Water Quality Report

Response to Submissions

4 MARCH 2011

Prepared for
Veolia Environmental Services

Figure 2-1 Woodlawn Seepage Model - Open Void

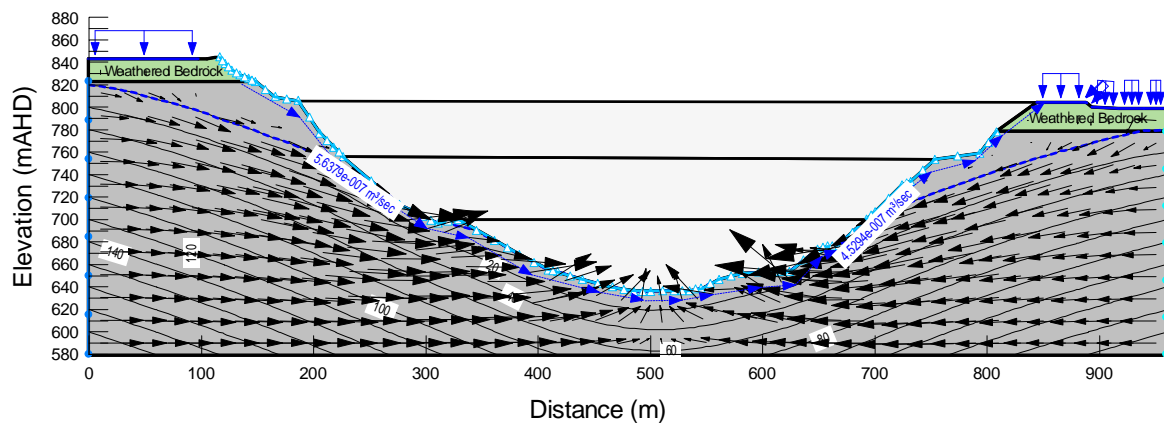
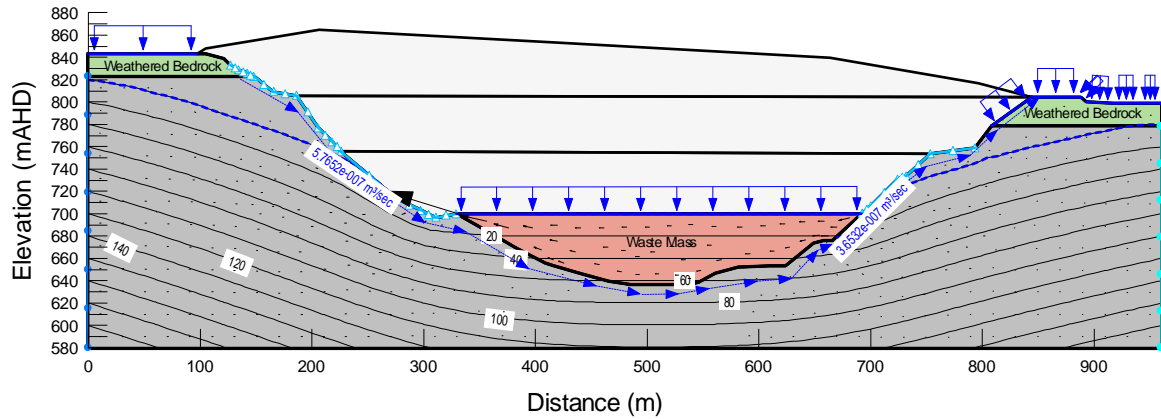
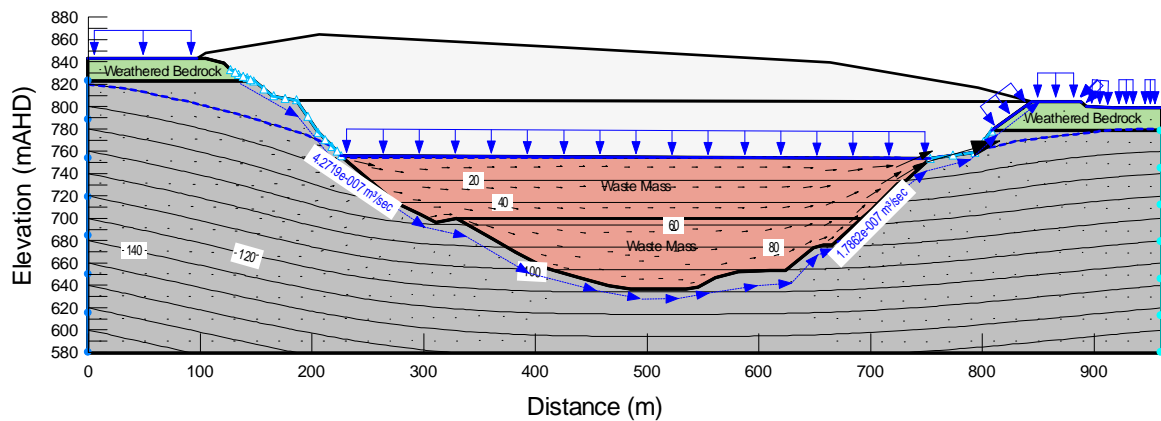
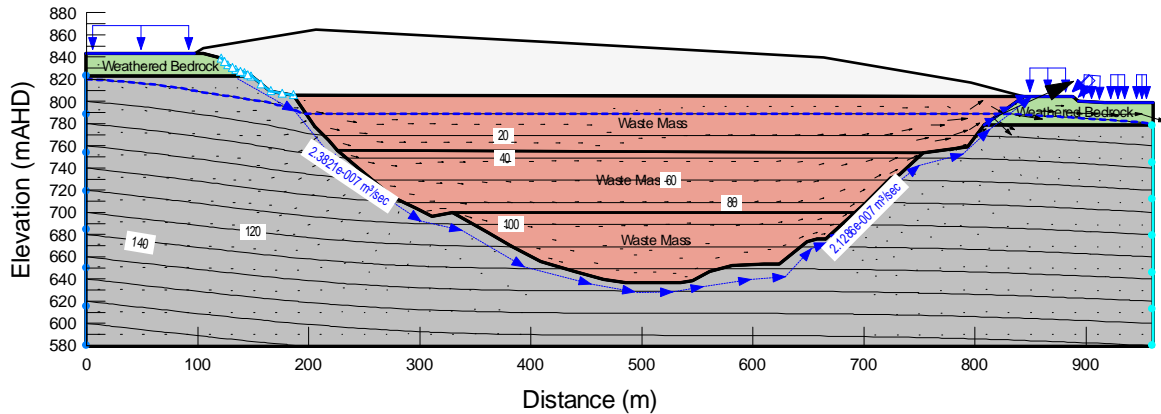
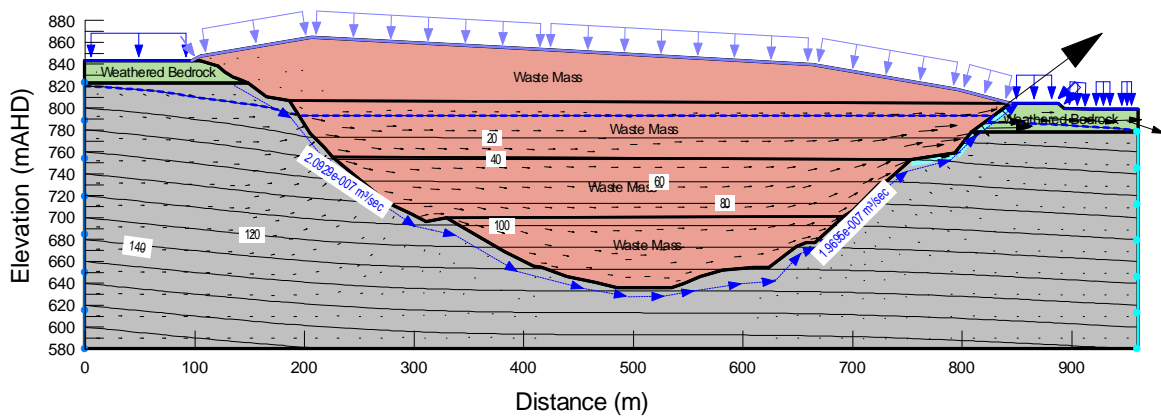
- 1. The SCA remains concerned that leachate generated when the landfill reaches a height at and above the more permeable surface rock near the current rim of the void may contaminate groundwater, surface water or soils outside the void. The leachate modelling is only done to a maximum waste level of 802.5mAHD, whereas the rehabilitation plan has the height of the centre of the bioreactor as 846.8mAHD.*

The water balance leachate modelling could only be carried out for the filling of the void to the lowest rim level at 802.5mAHD and therefore had to stop when the level of waste reached the level of the rim. The reason for this is that the equation for available storage in the waste mass is based on the geometry of the void. With filling above the rim, the use of the SEEP model is more appropriate and this is what is presented below.

The leachate modelling was carried out using the cross-sectional model SEEP which simulates horizontal and vertical fluid movement in the saturated and unsaturated zone. The model is shown in Figure 2-1 below.

A former hydrogeological study of the site indicated, through packer testing, that the hydraulic conductivity of the fractured rock mass is between 1×10^{-8} m/sec and 3×10^{-9} m/sec. Using an average value of 8×10^{-9} m/sec, the model indicates that the groundwater flow into the pit is approximately $60 \text{ m}^3/\text{day}$, or 0.7 L/sec . This is similar to the value observed at the sump of the mine pit prior to filling (c. 1 L/sec).

As the void is progressively filled, groundwater inflow decreases as the hydraulic gradient reduces. The filling sequence is simulated in the following figures. Steady state modelling was used to simulate groundwater conditions at various stages of filling. Figure 2-2 shows the current condition with the waste level at 700 mAHD. Subsequent stages are shown in Figures 2-3 to 2-5.

As the waste level rises, the bedrock becomes more weathered, and the SCA has pointed out that the weathered bedrock is more likely to have a higher permeability. To mitigate the potential for leachate migration from this more weathered zone, Veolia will selectively line the rock faces to ensure that the hydraulic conductivity is less than 1×10^{-9} m/sec. Such measures are already being undertaken in selected areas of the wall where higher permeability fracture zones are encountered. The impact of this liner is simulated in the SEEP model on the right hand rock face along the weathered bedrock zone.

WOODLAWN BIOREACTOR
 COMPLETED REHABILITATION
 SURFACE PLAN

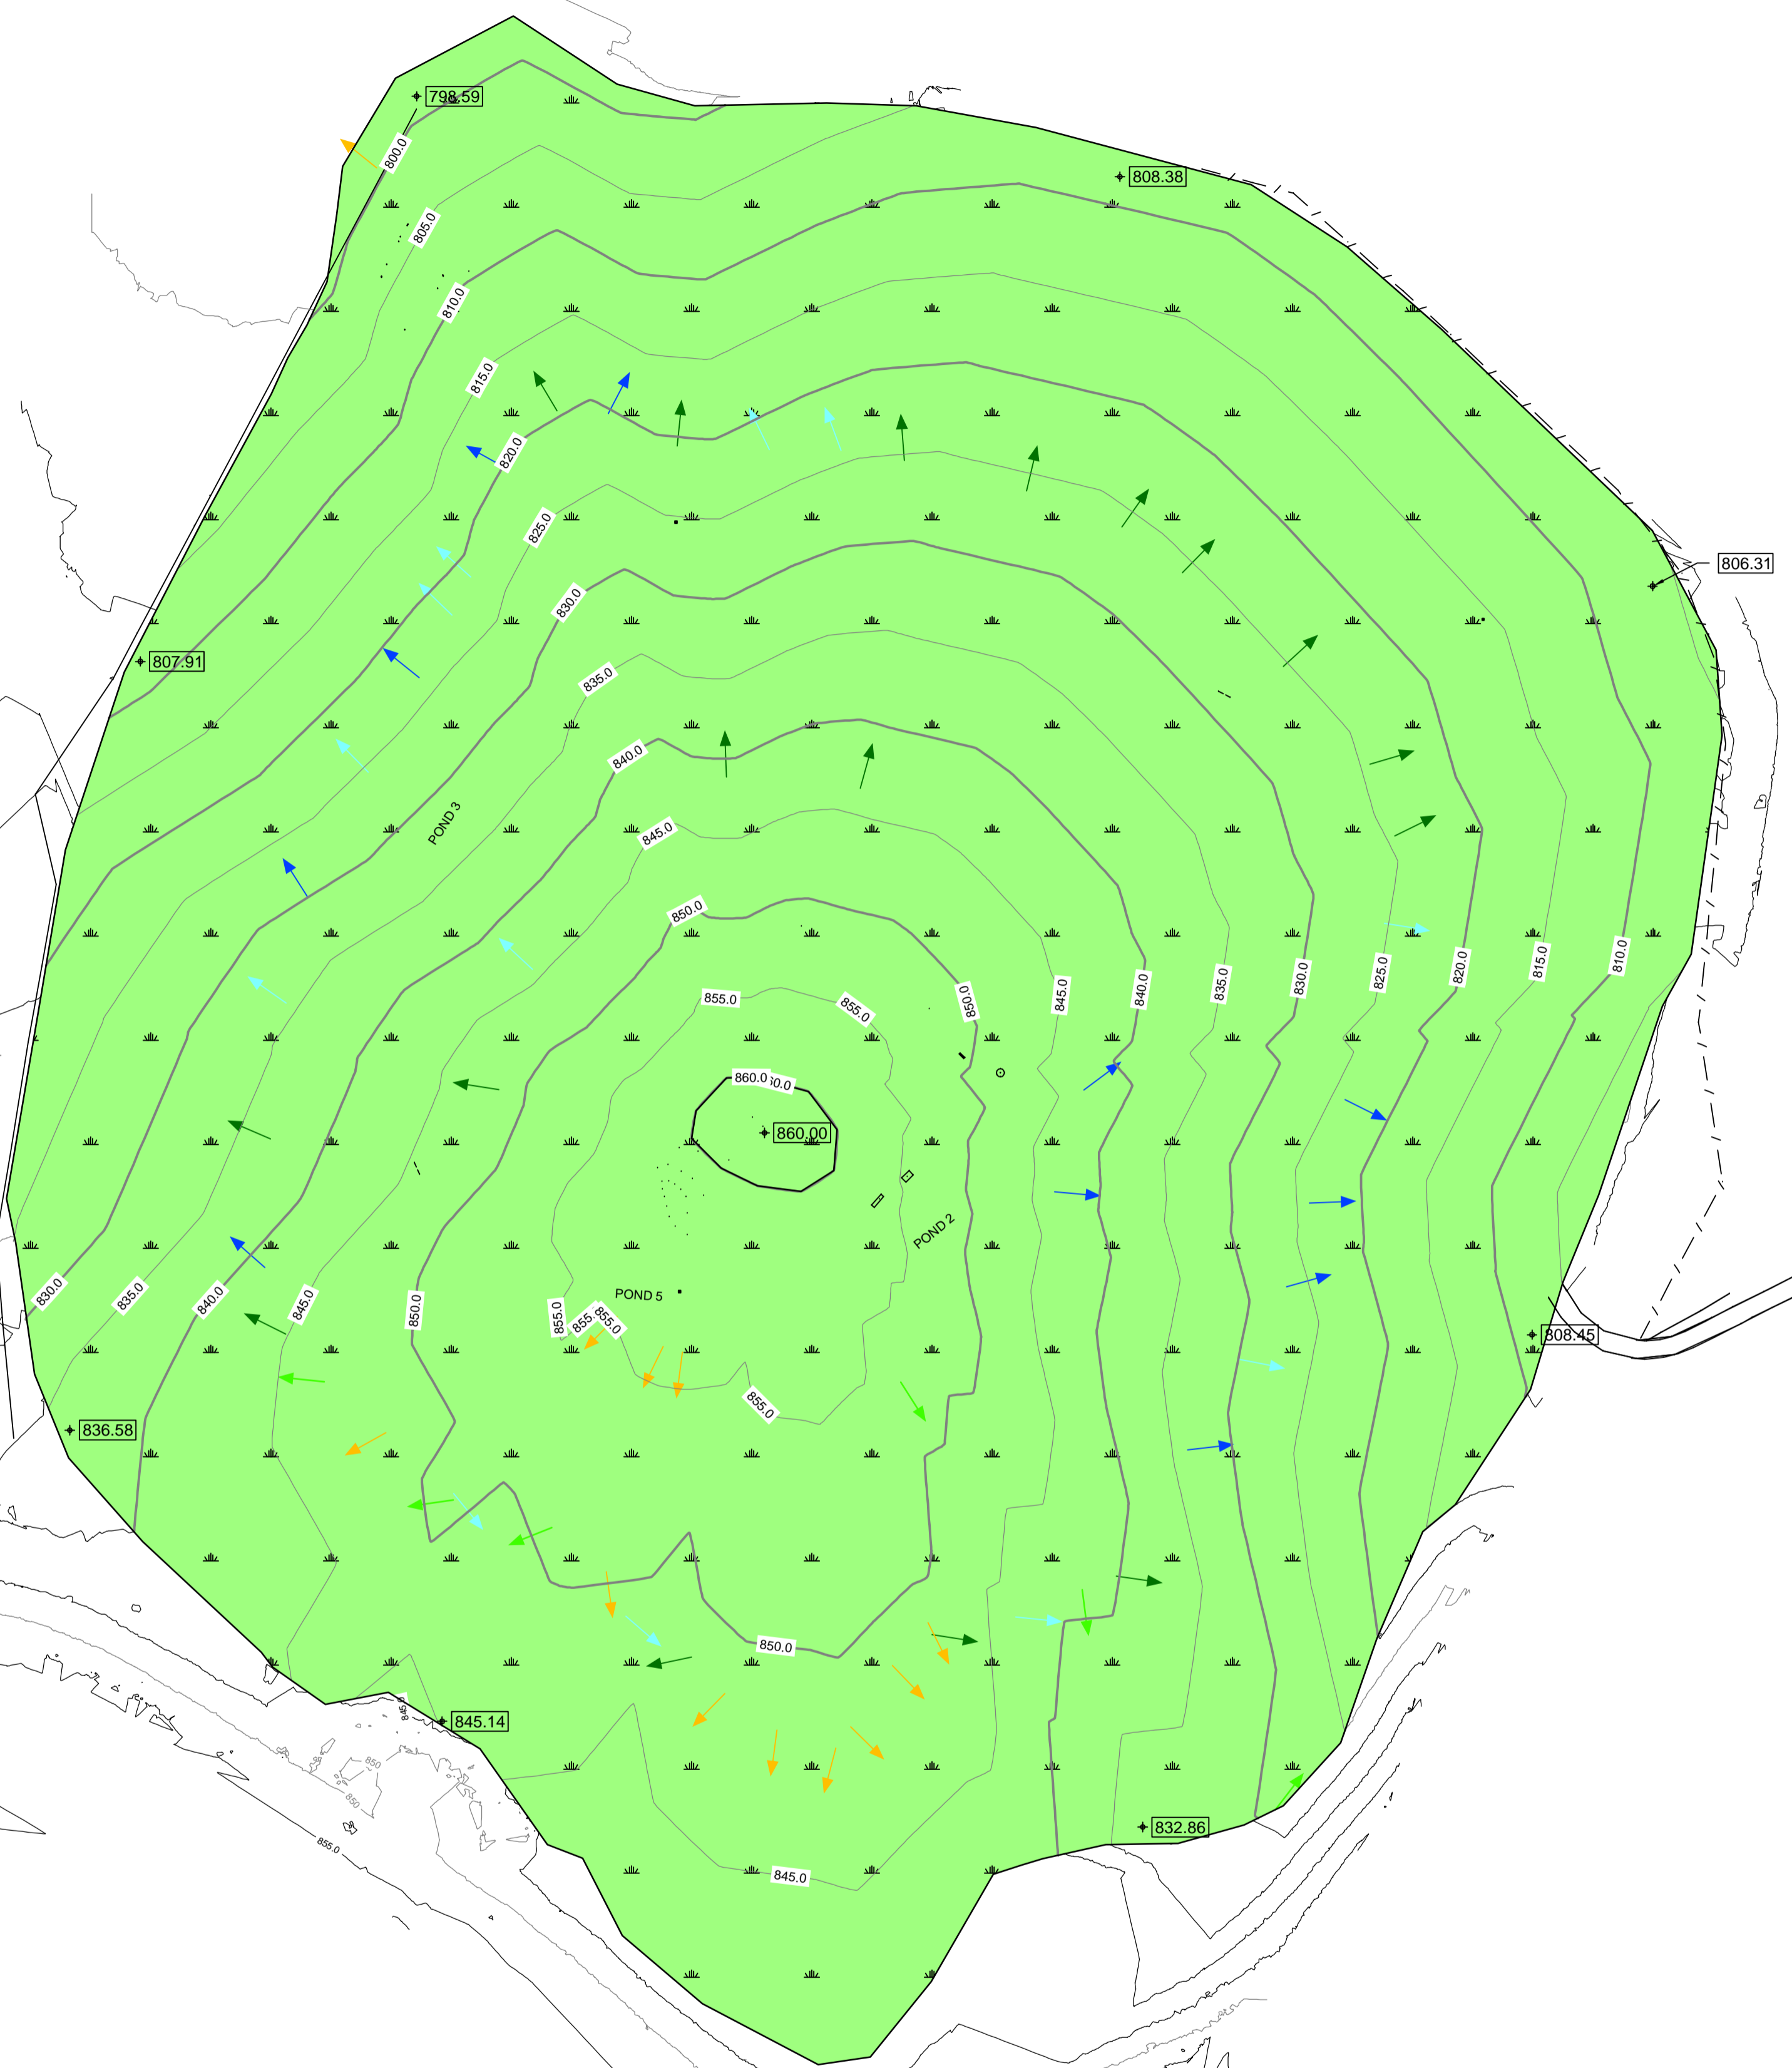
- 2. The EA poorly represents the relationship of the finished bioreactor profile to the existing mine void wall profile. The rehabilitation diagram 3.18 in Volume 2 Appendix K shows the RL on the finished surface being between 844.6 and 846.8m. Section 15.4 states that the height of the capped landfill will vary from 806 AHD to 810 AHD with the capping depths shown in Figure 14-1, (which is actually 15-1 in the assessment). Figure 8.6 shows the existing heights of the void ranging from 840 in the south to 805 m in the north. To achieve the rehabilitation profile shown in Figure 3.18, would require the expansion of the northern, western and eastern face of the landfill mass approximately 40 metres above the existing level of the rim of the void. The SCA considers the proponent should be required to provide accurate diagrams and that these should be superimposed with geological permeability data and local water table levels.*

SCA has requested clarification of the final capped surface level with appropriate design drawings. It is important that the final surface level of the cap has sufficient grade to facilitate runoff and to prevent ponding of surface water which would increase infiltration post-closure.

The maximum final post-settlement surface level of the cap is approximately 865 mAHD and the design provides for post-settlement slopes less than 20% and greater than 5% across the whole surface, in accordance with the Environmental Guidelines: Solid Waste Landfills, EPA NSW, 1996.

The final cap contours are shown in Figure and show that the final levels will join back in to the existing levels around the rim of the void.
